Work Order ID 90341

Item Name: Crosstube Mid Aft

DART AEROSPACE LTD HAWKESBURY, ONTARIO, CANADA	
DRAWING NO. D206-667-247	REV. A SHEET 1 OF 4
TITLE CROSSTUBE ASSY (206L MID AFT)	SCALE NTS

DRAWING NO. D206-667-247	TITLE CROSSTUBE ASS'Y (206L MID AFT)	REV. A	<b>DART AEROSPACE LTD ENGINEERING ORDER</b>		D.E.O. NO. D206-667-247-A-1	SHEET NO. SHEET 1 OF 1	SCALE NTS
DRAWN 9	CHECKED ASS	MFG. APPR. [Signature]	APPROVED [Signature]	DE APPR. [Signature]			
DATE 11.07.15	DATE 11.07.20	DATE 11.07.21	DATE 11/07/21	DATE 11.07.21

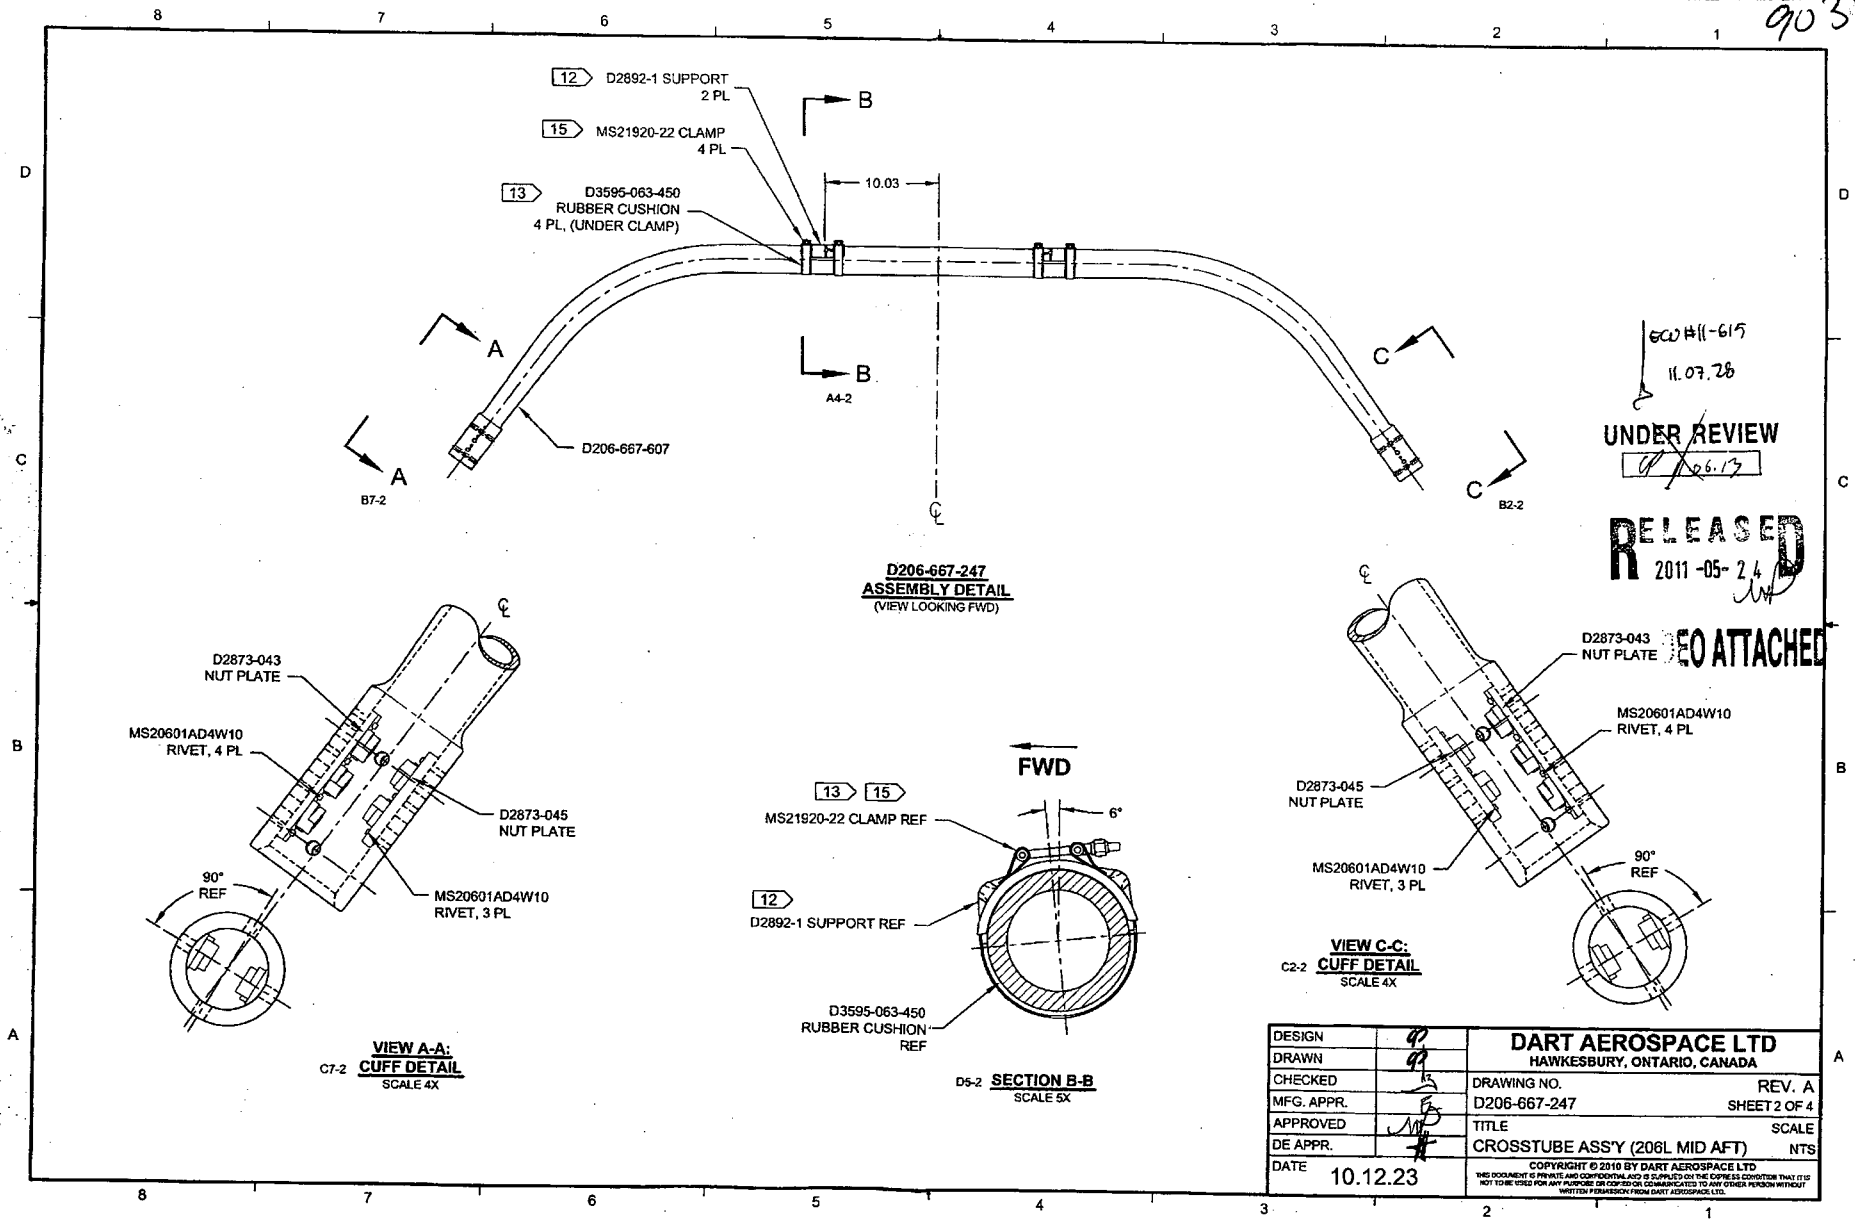
REPLACE MAGNOBOND WITH PROSEAL.

NOTE 12 & 15, SHEET 1 IS AMENDED AS FOLLOWS:

- 12) TO INSTALL D2892-1 SUPPORT: ABRASE MATING SURFACE OF SUPPORT AND CROSSTUBE WITH 180-GRIT SANDPAPER AND REMOVE RESIDUE WITH MEK (OR EQUIVALENT). APPLY A 0.04" TO 0.07" THICK LAYER OF PROSEAL 890 CLASS B-2 (OR AMS-S-8802 CLASS B-2) SEALANT TO MATING SURFACE OF SUPPORT.
- 15) TORQUE CLAMPS 80 TO 100 IN-LB. ENSURE AT LEAST 1.5 THREADS SHOWING IN SAFETY AND THAT NUT HAS NOT BOTTOMED-OUT AFTER TORQUING. **PRIOR TO PACKAGING, RE-CHECK TORQUE ON CLAMPS AFTER PROSEAL 890 SEALANT HAS CURED FOR 72 HOURS.**

- 12) INSTALL D2892-1 SUPPORT USING 0.03" TO 0.06" THICK LAYER OF MAGNOBOND 6398 PER QSI 015. LET CURE FOR 12 HOURS AFTER INSTALLATION AND PRIOR TO PACKAGING.
- 15) TORQUE CLAMPS 80 TO 100 IN-LB. ENSURE AT LEAST 1.5 THREADS SHOWING IN SAFETY AND THAT NUT HAS NOT BOTTOMED-OUT AFTER TORQUING.
